# Powerhouse Ultimo Renewal

Submissions and Amendment Report

500 Harris Street, Ultimo

**Figure 1** Illustration of revised maximum building envelope

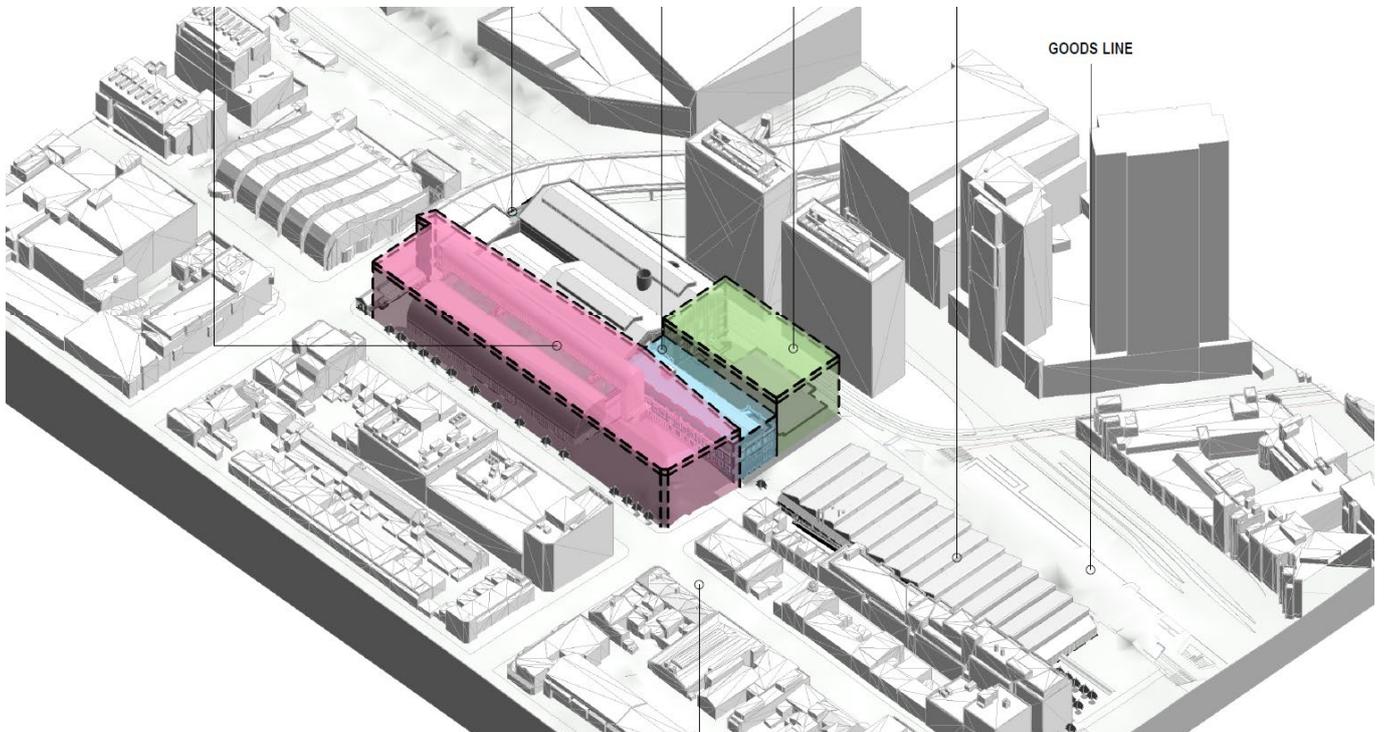
In response to submissions received during the exhibition period, the previously proposed building envelopes above the State Heritage-listed Turbine Hall, Boiler House, North Annex/ Office Building and Former Ultimo Post Office have all been removed. No significant new building work is envisaged within these areas, and any minor works (e.g. heritage conservation works and building upgrades) and internal fitout works proposed as part of the Stage 2 Detailed SSDA would be required to demonstrate consistency with the Conservation Management Plan.

A building envelope is proposed to be retained above the Switch House, where an existing modern vertical addition comprising a new rooftop/mezzanine level has already resulted in the removal of the original roof fabric and form. The maximum height of the revised building envelope in this location would be limited to the ridge height of the existing modern rooftop (RL 27.88 AHD), and any new development in this zone proposed as part of the Stage 2 Detailed SSDA would be required to demonstrate consistency with the Conservation Management Plan.

In response to submissions received during the exhibition period, the maximum proposed height for the building envelope within Zone 3 has been reduced to RL 13.08 AHD, being generally level with the height of the existing Pier Street roadway. This amendment will continue to allow the option of developing future structures within this zone in accordance with the Urban Design Guidelines and Conservation Management Plan in order to facilitate potential connections through to Pyrmont Street to the north. It also facilitates opportunities to incorporate the Pump House remains identified in the Heritage Impact Statement as part of the detailed design for the purpose of the future Detailed SSDA.
